**Project # PR-2018-001482**  
SI-2023-01925 - Site Plan - EPC

Tierra West, LLC, agent Riverside West, LLC, requests a new Site Plan-EPC, for all or a portion of Tract 1 of Summary Plat Land Division of West Land Development Co., included together with A Tract of land within these 1/4 SE, 1/4 SEC, 34 T10N, and R2E and a Tract of land east of Amole Del Norte Diversion Channel North of Section line of section 34 & 3, located at 2911 Ervien Ln. SW, north west of the intersection of Ervien Ln and Coors Blvd., approximately 42 acres. (M-10-Z)  
Staff Planner: William Steele

RE: PR- PR-2018-001482, SI-2023-01925–Site Plan-EPC \_ Riverside Mobile Home Park

ENGINEER'S SEAL

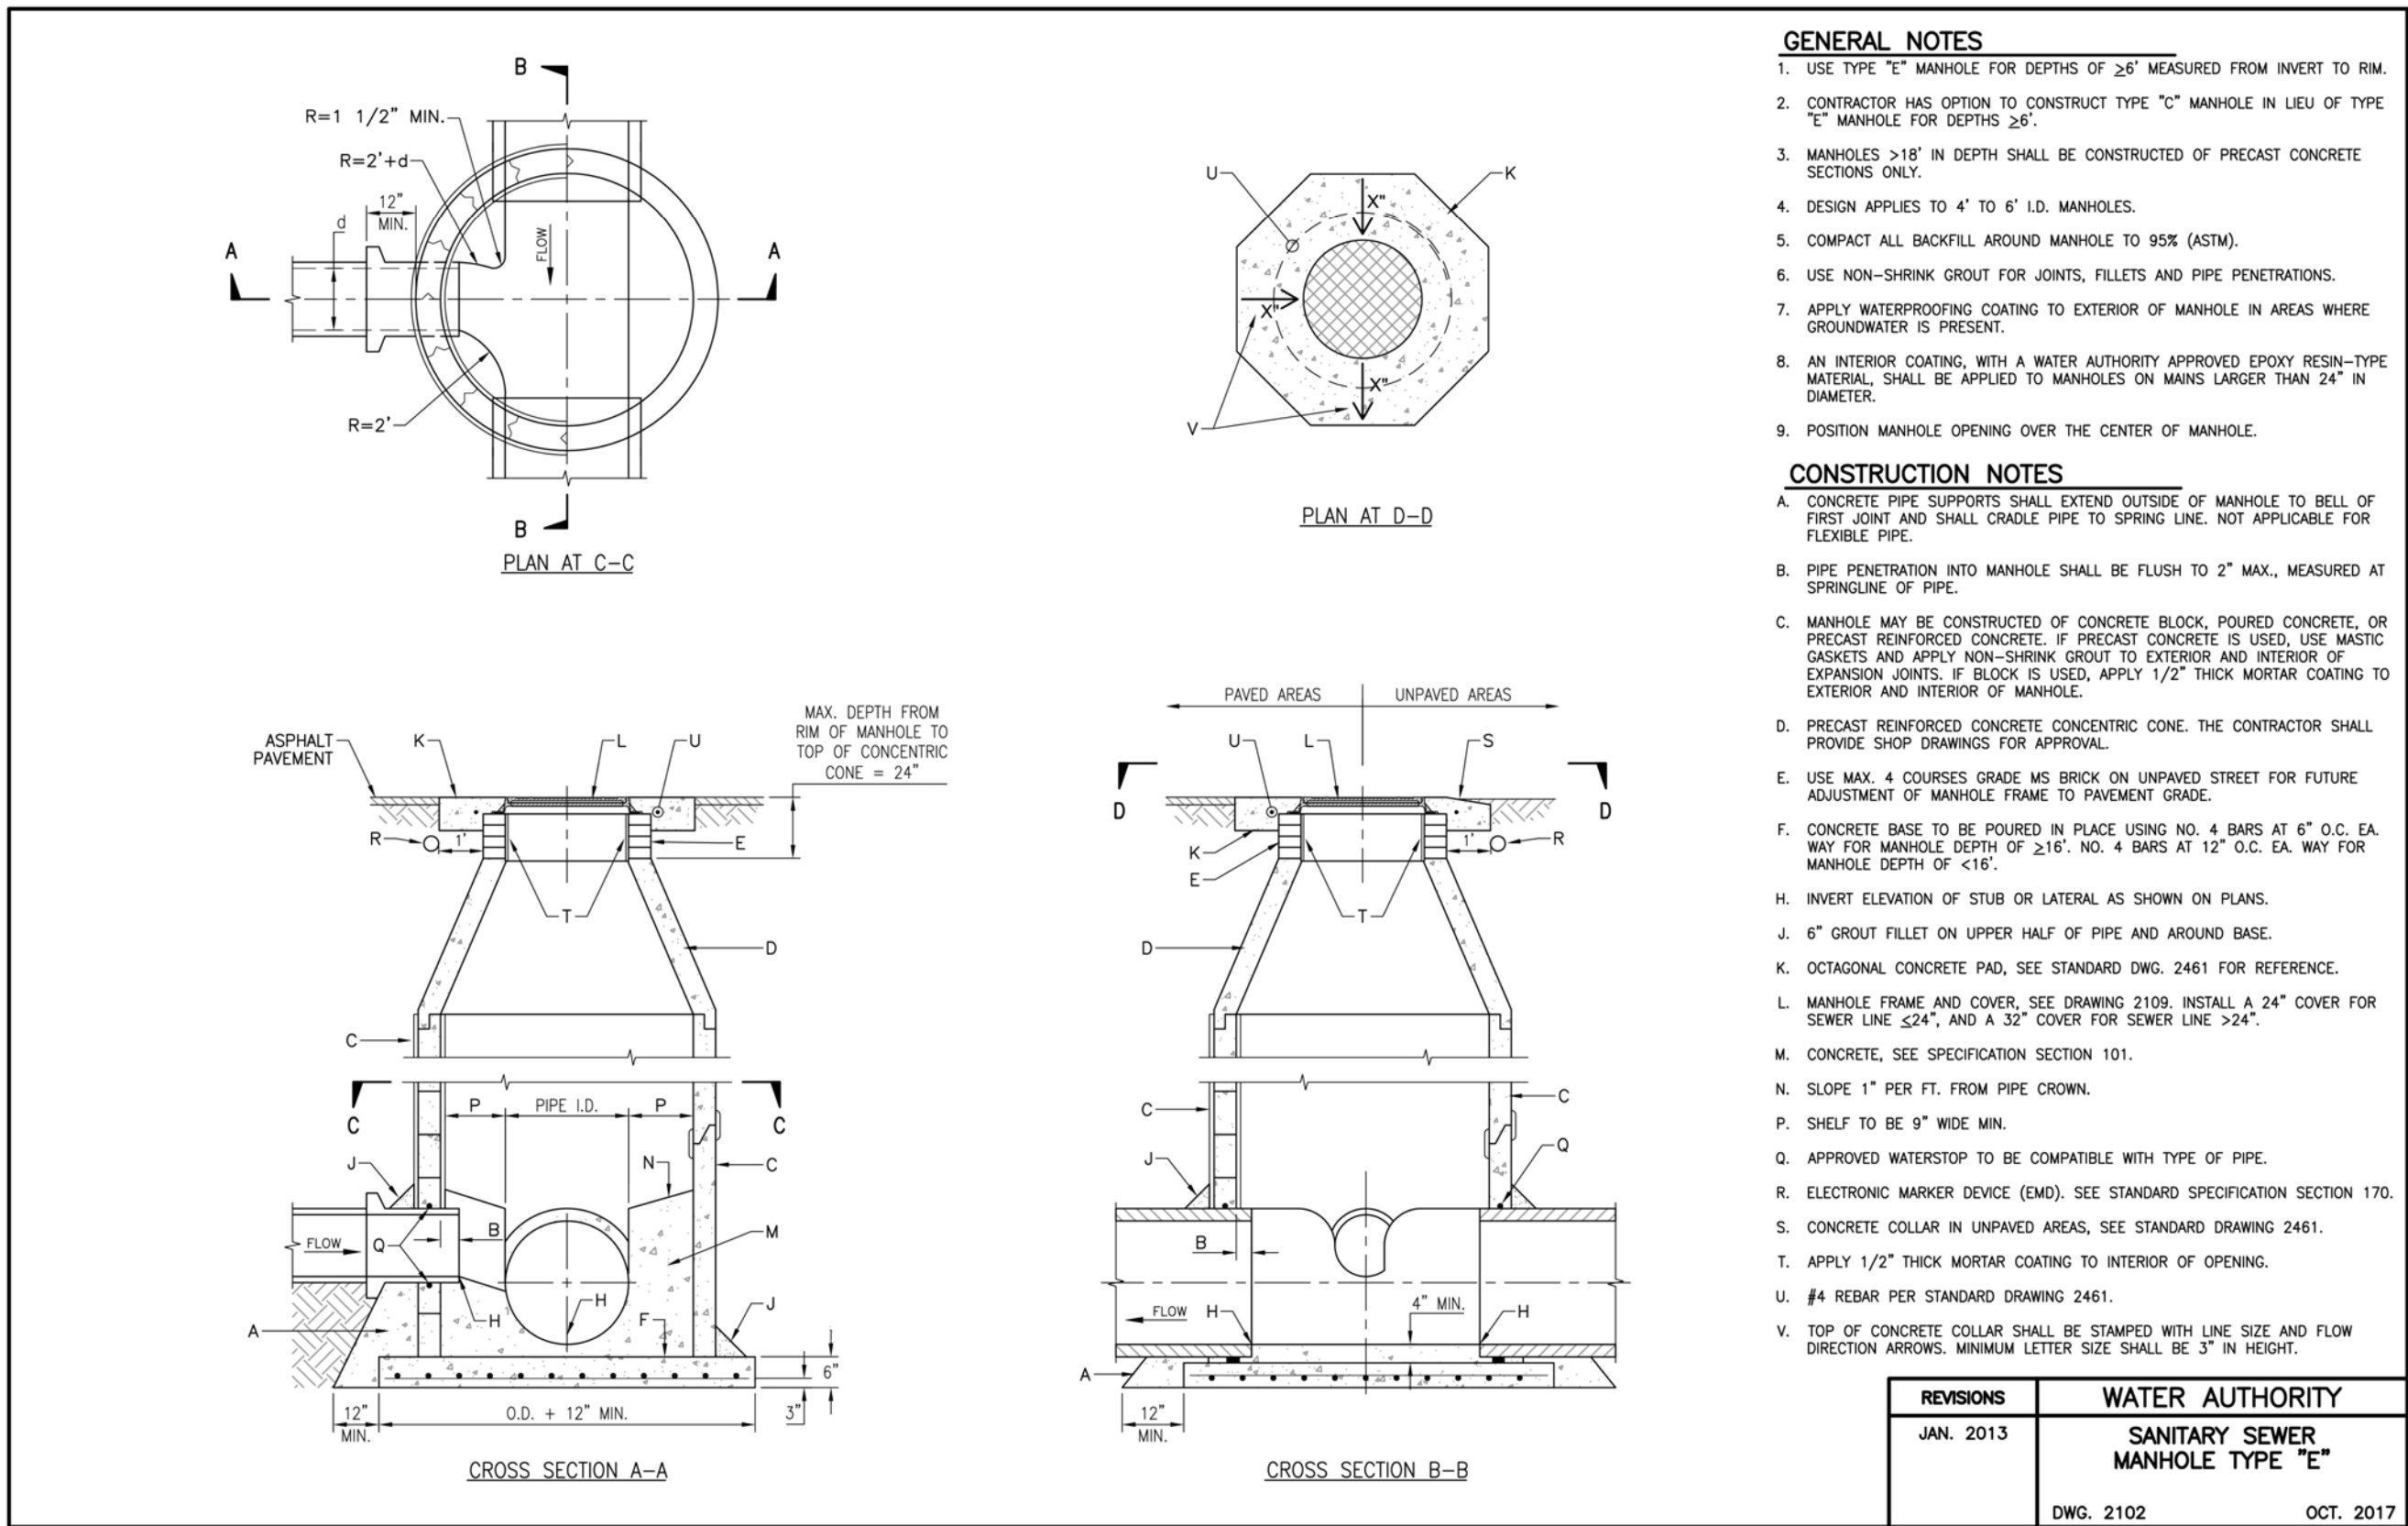
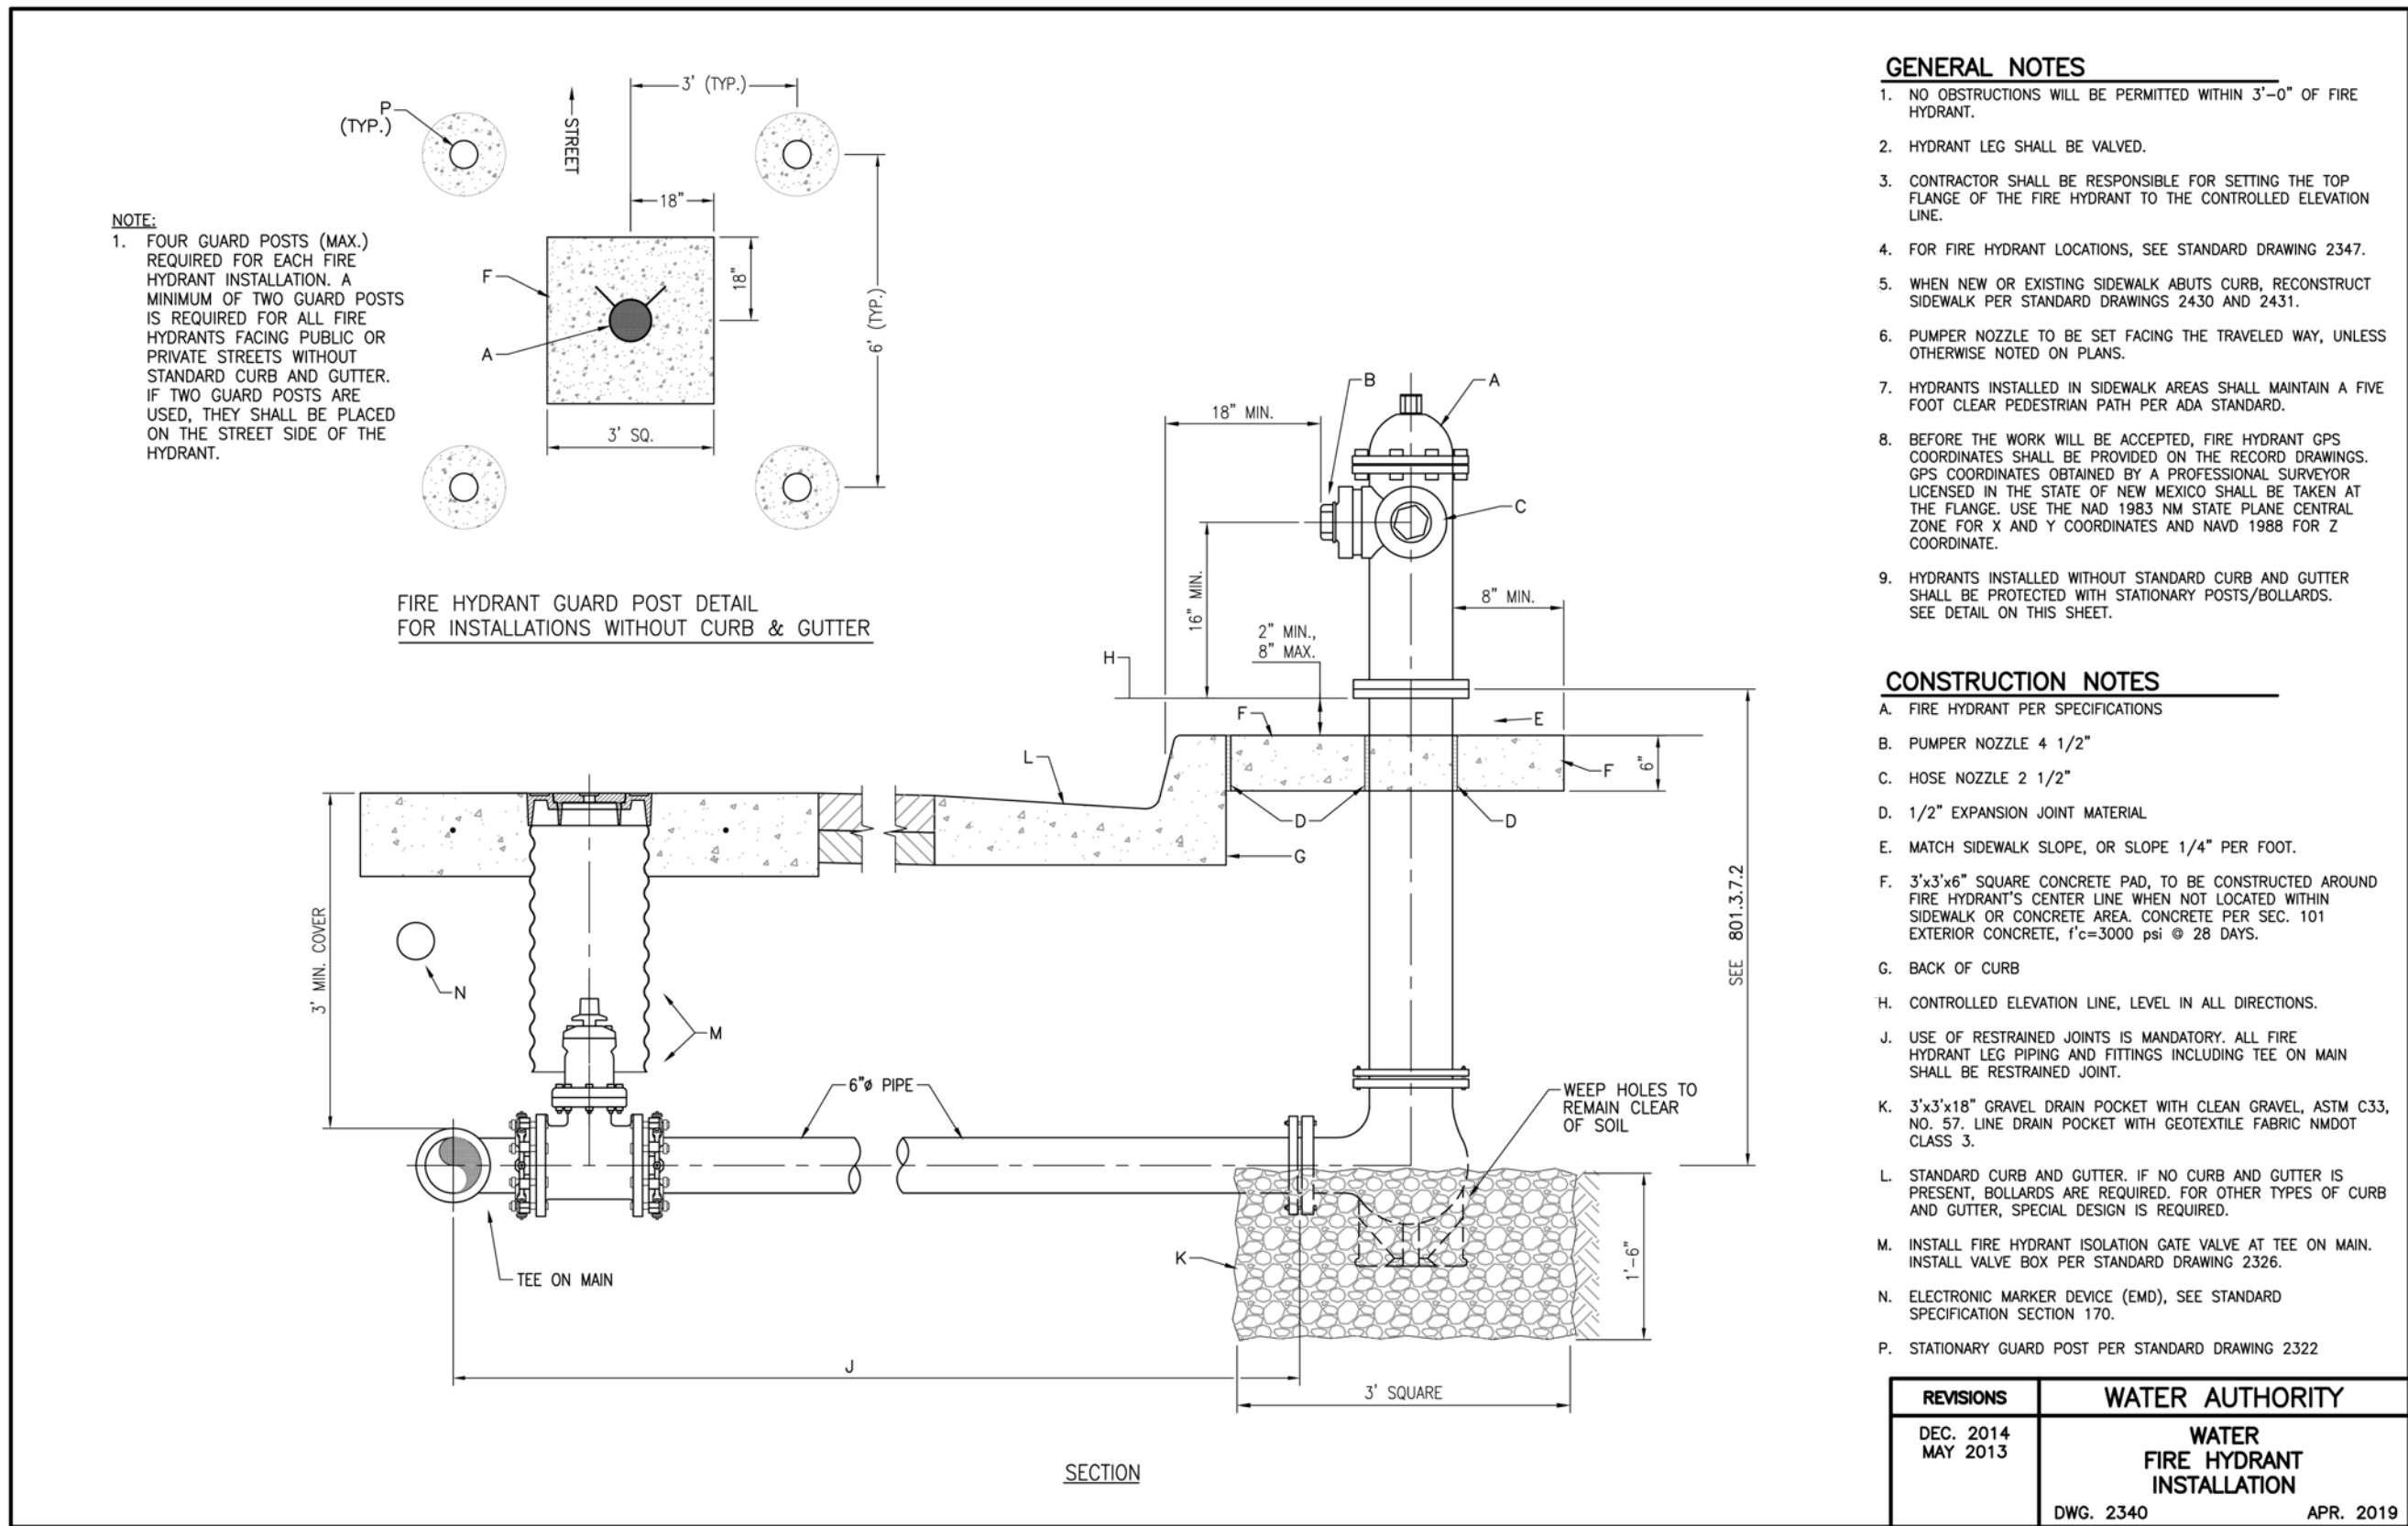
**Response:** Sheets were added back into the plan set.
2. **Comment:** Detail Sheet C5.1, detail for Parallel and Diagonal Curb Ramps was removed. Please reinstate

**Response:** Detail was reinstated.
3. **Comment:** The Landscape Sheet numbering has been changed from L1.0 to LS-101 and no longer matches the Index to Drawings on the Site Development Plan Sheet. Please revise.
